THE CITY OF SAN DIEGO

## MEMORANDUM

SUBJECT: Item No. 1 - 6110 Camino de la Costa Project No. PRJ-1066101 - Edits to Staff Report, issuance of an errata to the Environmental Impact Report and edits to draft hearing documents

**6110 Camino De La Costa  
Environmental Impact Report  
PRJ-1066101 / SCH No. 2023070270  
August 5, 2024**

A0.0

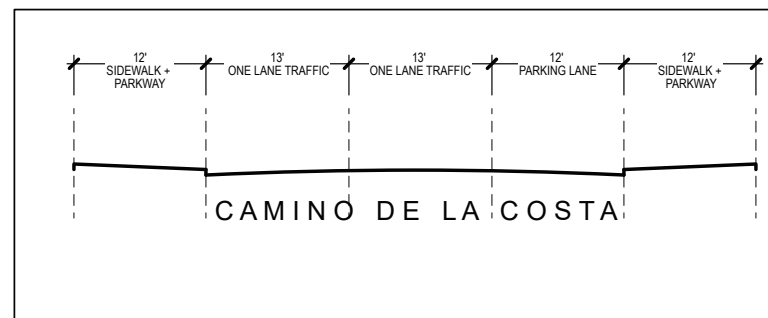
16. [Plan sheet No. A0.0 – Site Plan] Revised driveway width on the site plan from an eighteen-foot wide driveway to a twelve-foot wide driveway.
